ADDENDUM 3

DATE: November 18, 2016
PROJECT: MSB First Floor Infill LRC 3 & 4
RFP NO: 744-R1705
OWNER: The University of Texas Health Science Center at Houston
TO: Prospective Proposers

This Addendum forms part of and modifies Proposal Documents dated, October 19, 2016, with amendments and additions noted below.

Partition Types and Interior Construction Details

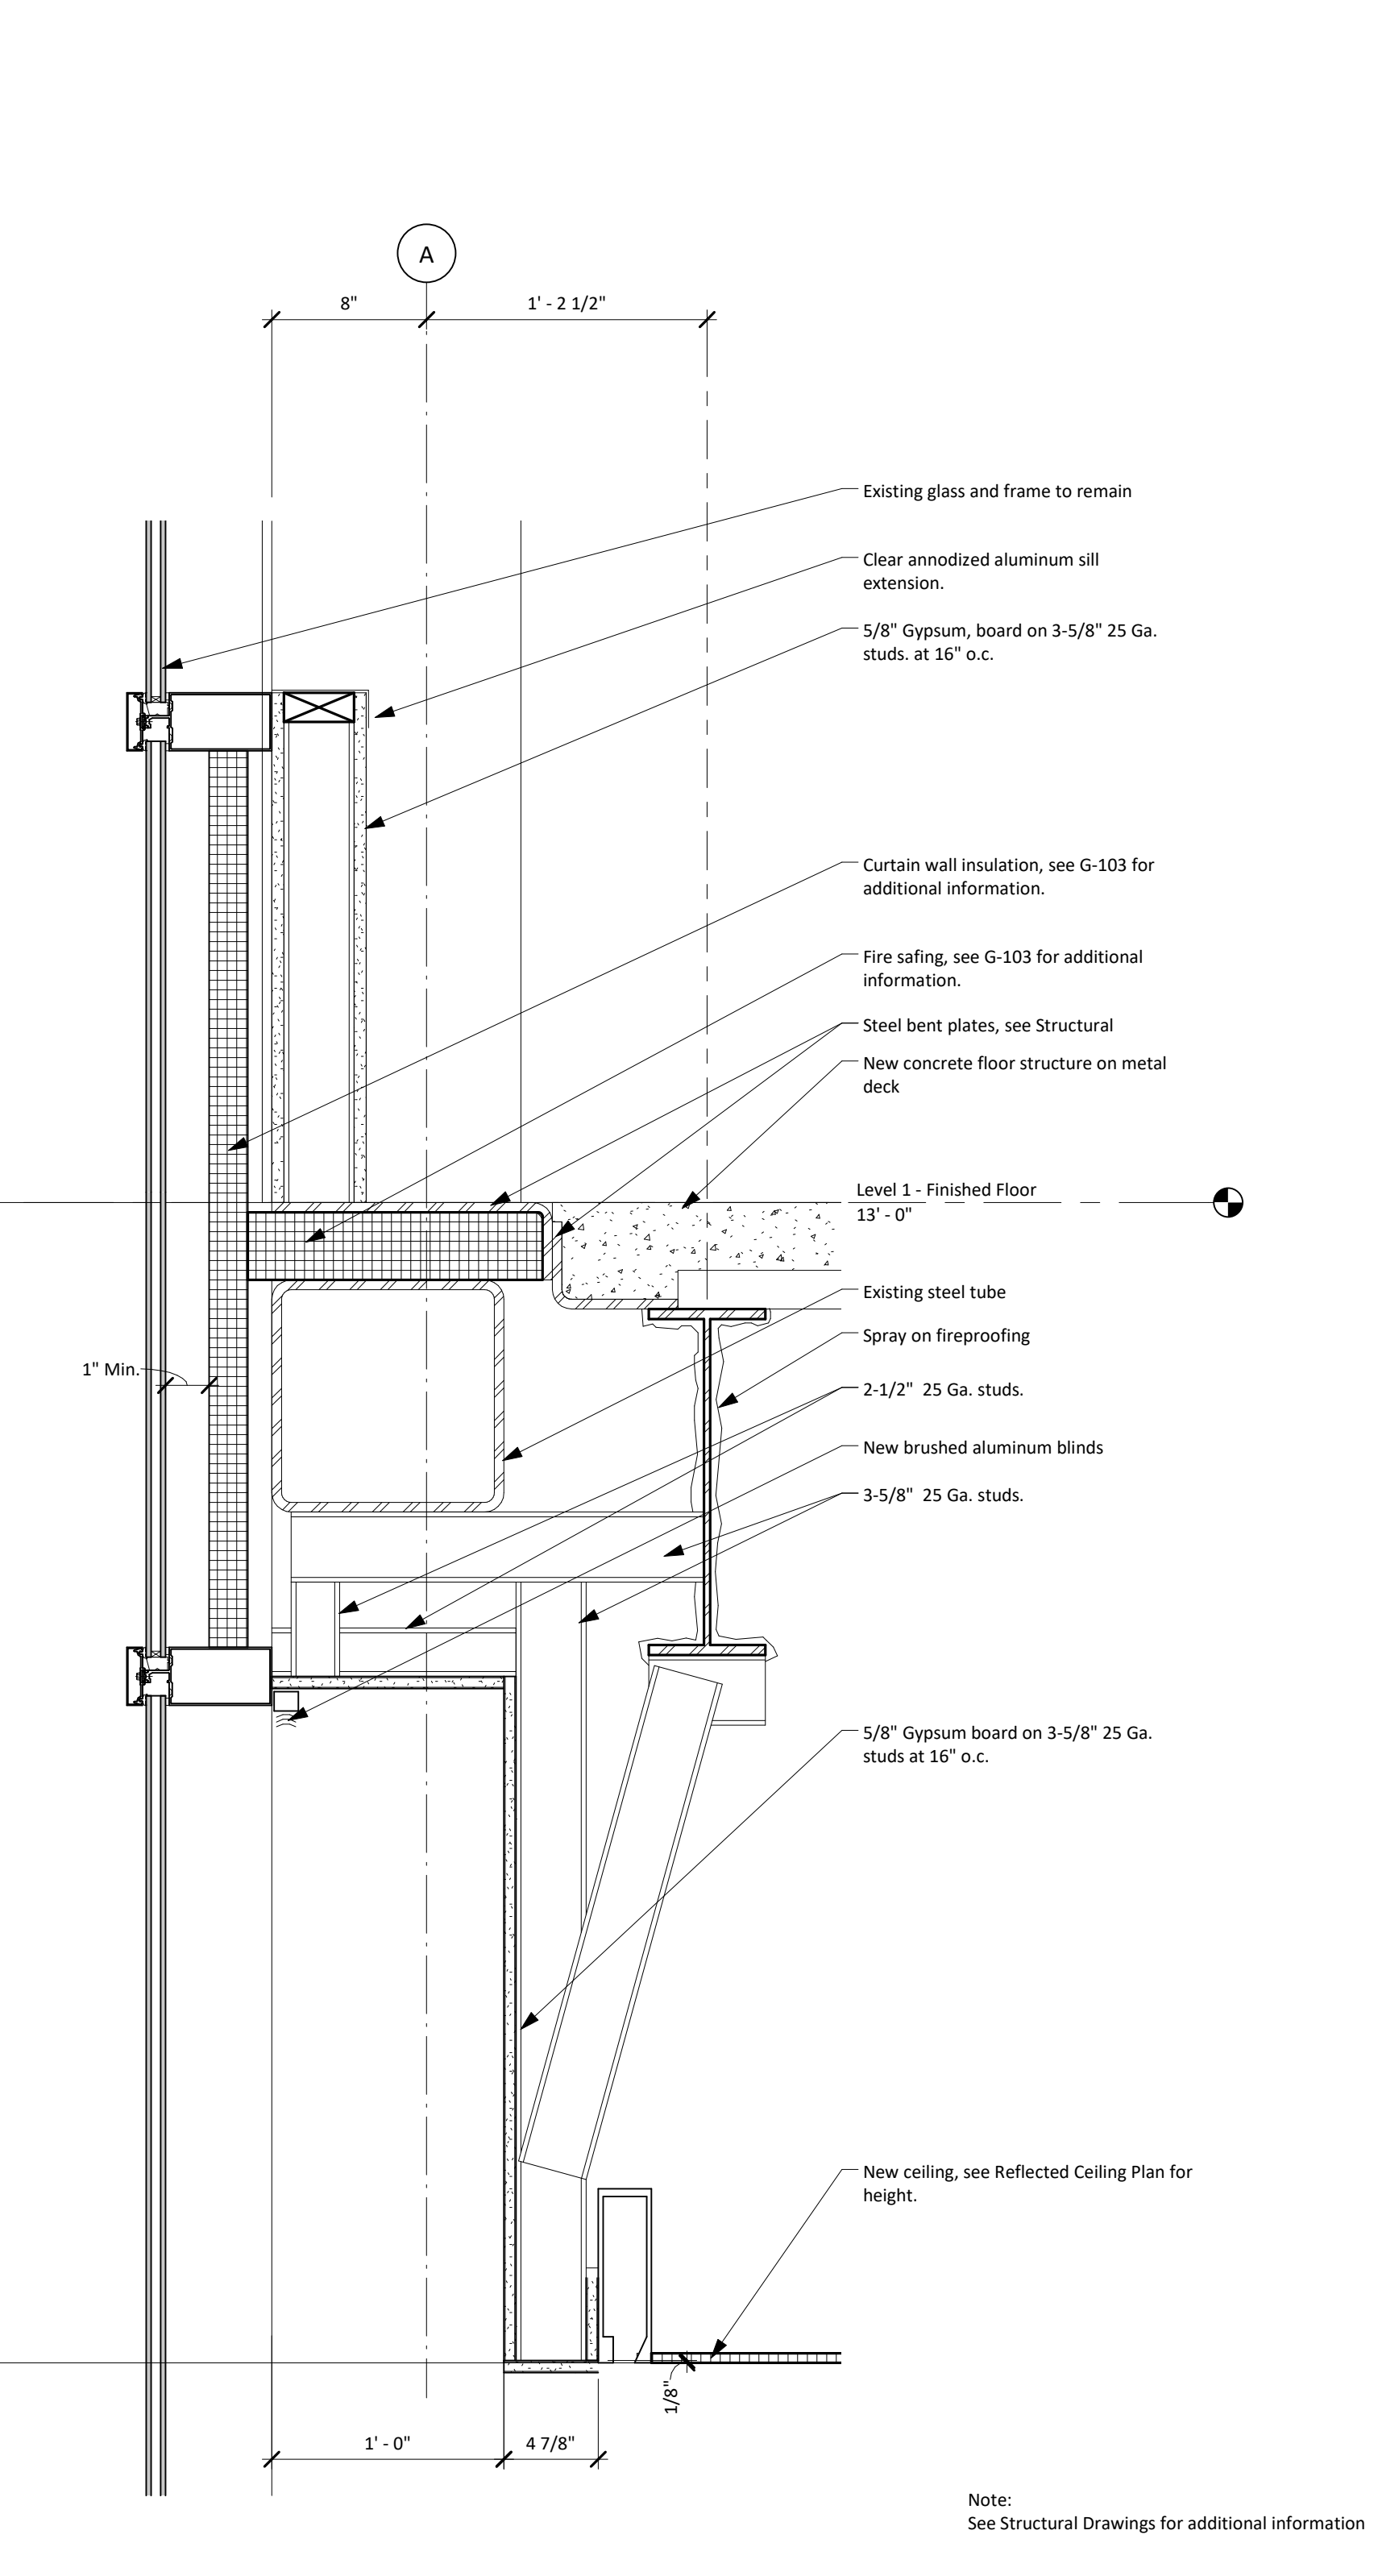
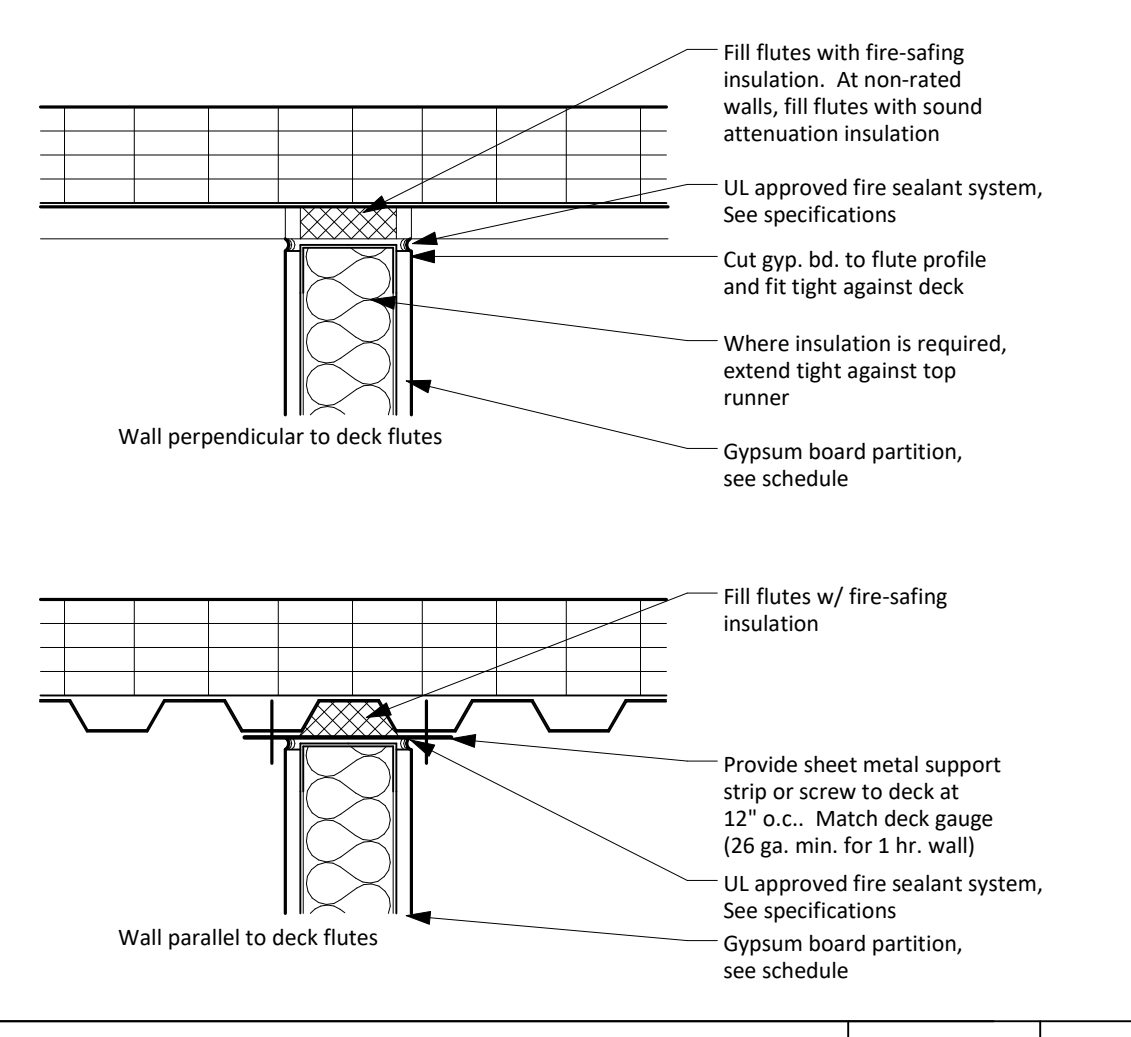
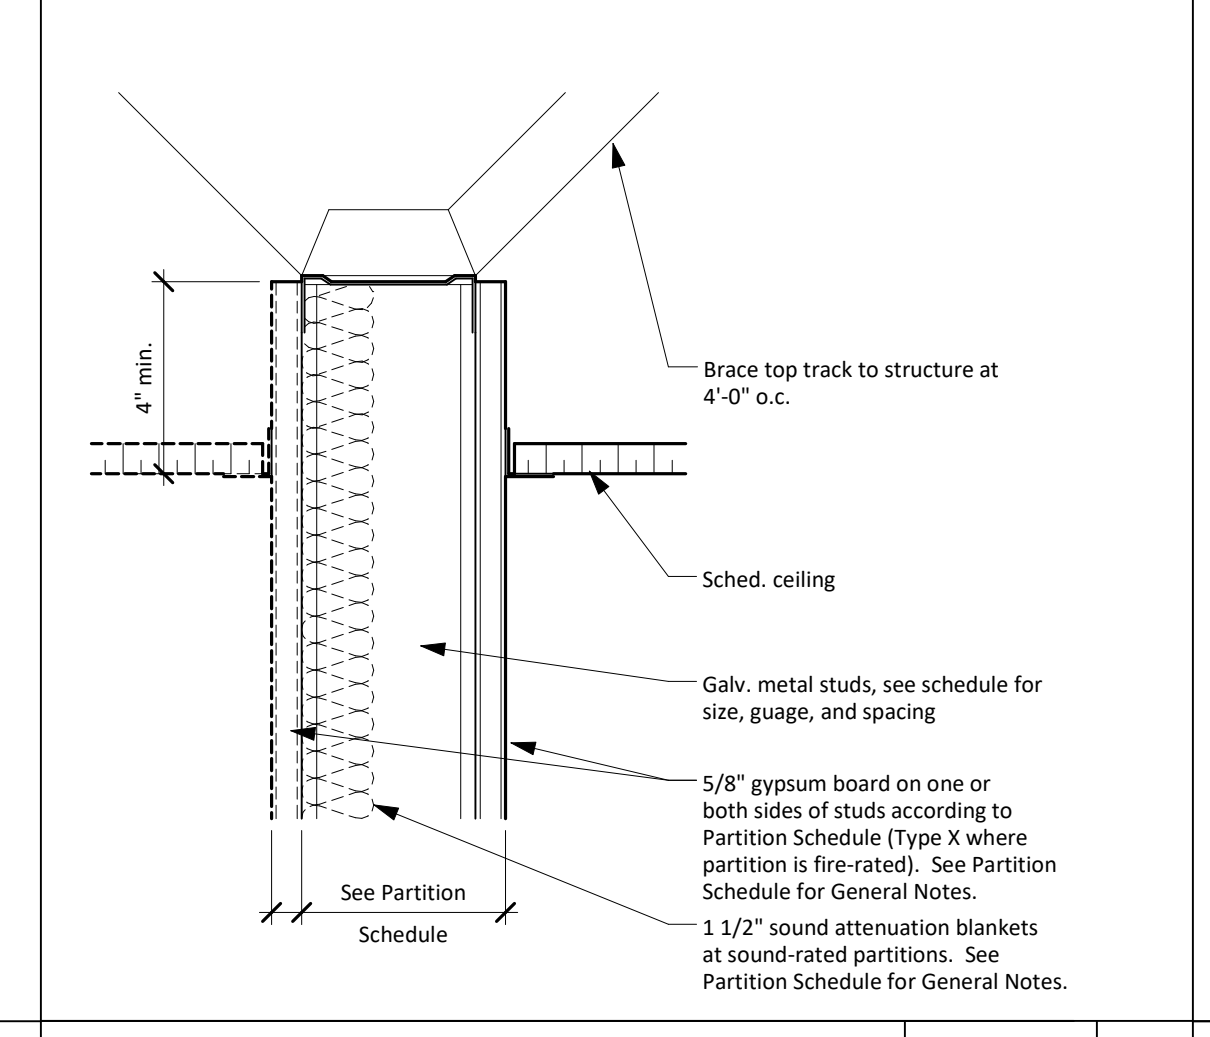
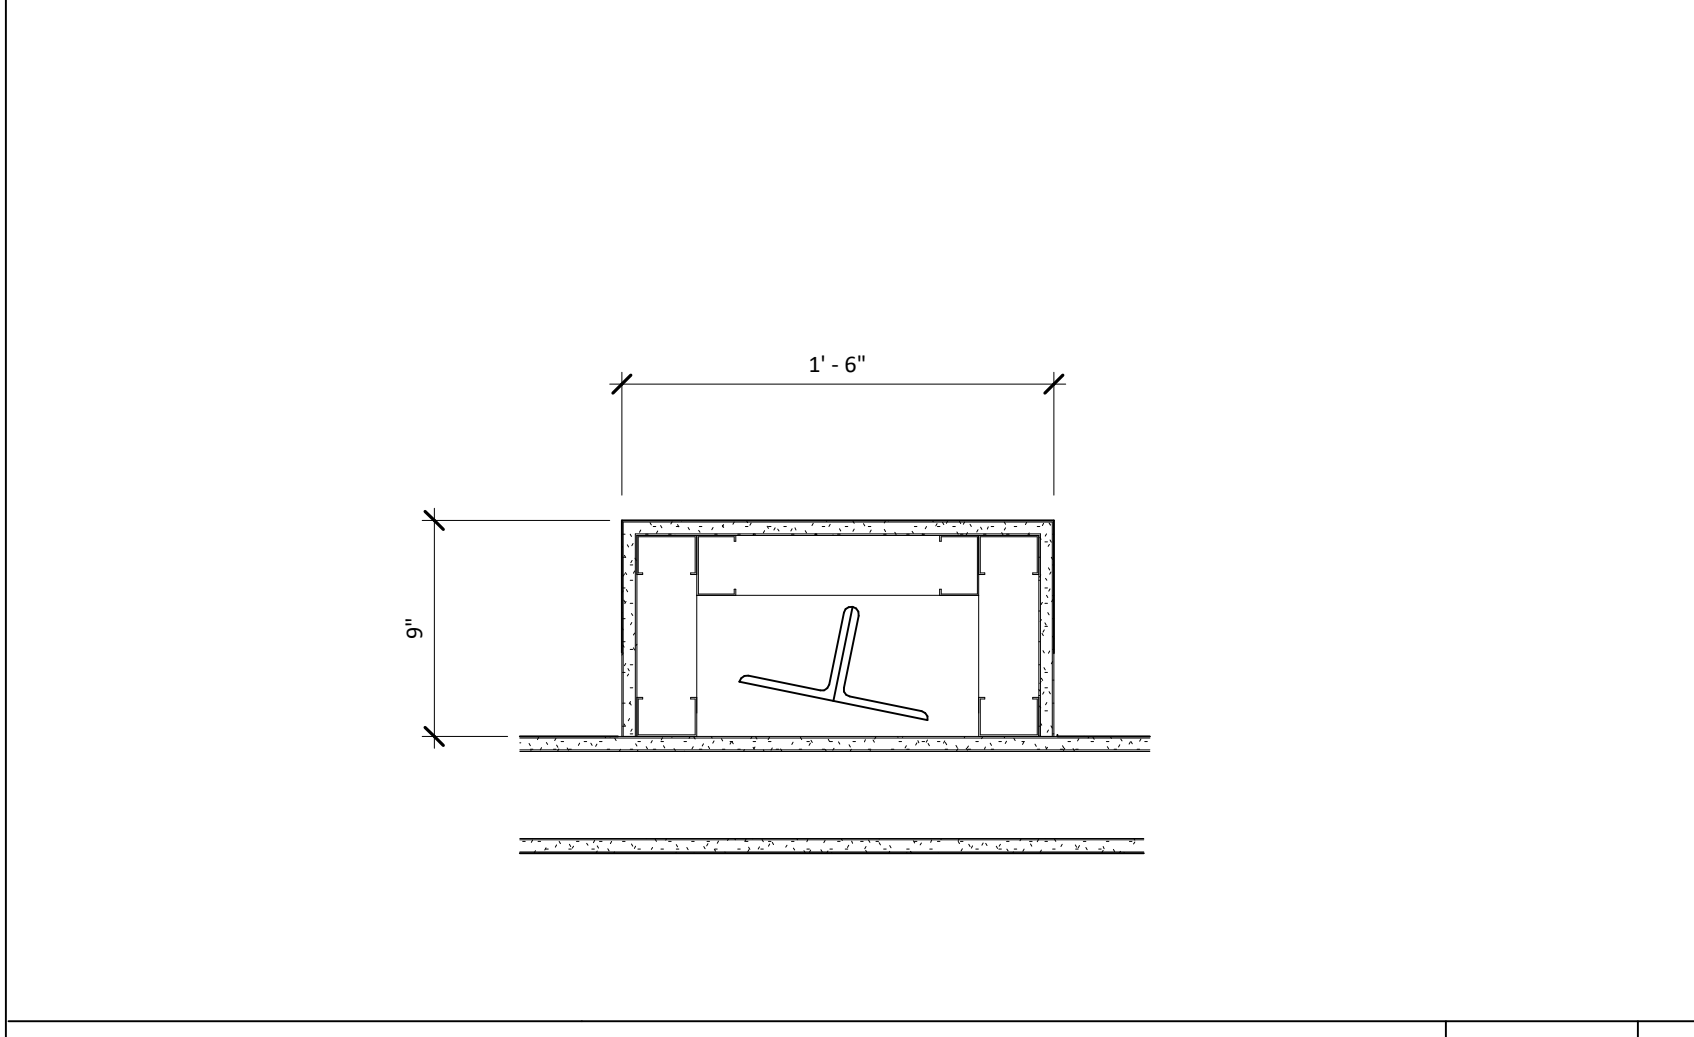
15. Provide a revised sheet showing exit signs to be replaced in Alternate #3.
Addressed within this Addendum.
16. Please provide a spec section for the "black-out" window film called out for on detail 16 on A-520.
Existing spandrel glass, note removed

17. Please provide details, 21/A-520, 22/A-520 and 23/A520. They are called out in the partition type schedule but are not shown on sheet A-520.
Wall type removed, will not be rated

23. On drawing A-520 - Partition Types and Interior Construction Details (Detail 18), detail shows ceiling to tie in to top of window with slot diffuser. The top of existing window is below the 9' ceiling height that is called for on the plans. Please advise. **Ceiling heights are now 8' ceilings, furr down will be required. New detail provided within this addendum.**

28. On drawing A-540 – Please confirm the notated door color is correct.
VT Industries Red Oak Veneer/ Alpine AL07
29. On drawing 16/A520 – Please provide specifications for the aluminum sill extension shown.
Included within this Addendum.
